Access Compliance Report Public Rights-of-Way (Curb Ramps)

Intersection ID: 17742 Main Street: S_WENDOVER_RD Cross Street: PROVIDENCE_RD Location: SE

ADA ID: 2C27C06FE687 Ramp Type: PerpDiag Initial Pass/Fail: Fail Overall Compliance: No Severity Score: 22.5

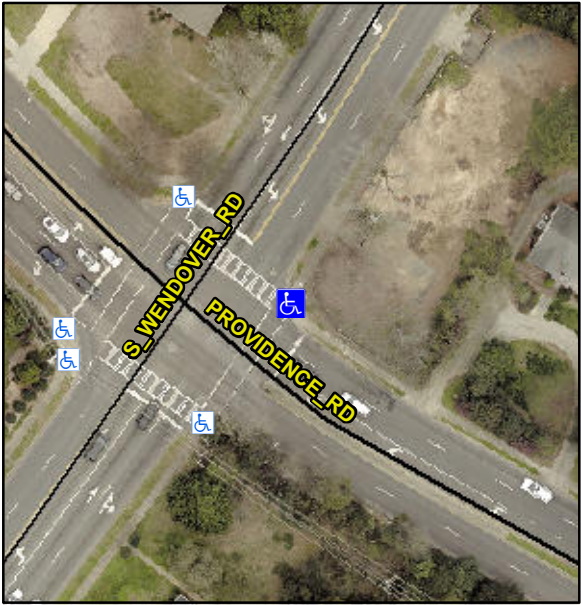
PROW/ADA:
Not Found, R304.5.1, R304.2.2, R304.5.3

Compliance	Description	Data	Compliance	Description	Data
N/A	Ramp Length (in)	50.0	No	Ramp Slope (%)	11.8
No	Ramp Width (in)	36.5	No	Ramp XSlope (%)	3.0
N/A	Flare Type LT	N/A	N/A	Flare Type RT	N/A
N/A	Flare Slope LT (%)	N/A	N/A	Flare Slope RT (%)	N/A
N/A	Flare Traversable LT?	N/A	N/A	Flare Traversable RT?	N/A
N/A	Landing Length (in)	N/A	N/A	DWS Provided?	N/A
N/A	Landing Width (in)	N/A	N/A	DWS Contrast?	N/A
N/A	Landing Slope (%)	N/A	N/A	DWS Length (in)	N/A
N/A	Landing X Slope (%)	N/A	N/A	DWS Full Width?	N/A
N/A	Landing Curb? (Y/N)	N/A	N/A	DWS Offset (in)	N/A
N/A	Shared Landing?	N/A			
N/A	Gutter Ponding?	N/A	N/A	Gutter Slope (%)	N/A
N/A	Gutter Lip Ht (in)	N/A	N/A	Gutter X Slope (%)	N/A
N/A	Painted X Walk1?	Yes	N/A	Painted X Walk2?	Yes
	X Walk 1 Direction	To NW		X Walk 2 Direction	To SW
N/A	X Walk 1 Width (in)	105.5	N/A	X Walk 2 Width (in)	102.5
	X Walk 1 Slope (%)	3.5		X Walk 2 Slope (%)	5.6
	X Walk 1 X Slope (%)	4.8		X Walk 2 X Slope (%)	1.9

Possible Solutions:
Remove & Replace Curb Ramp With Two New Directional Ramps or Equivalent.
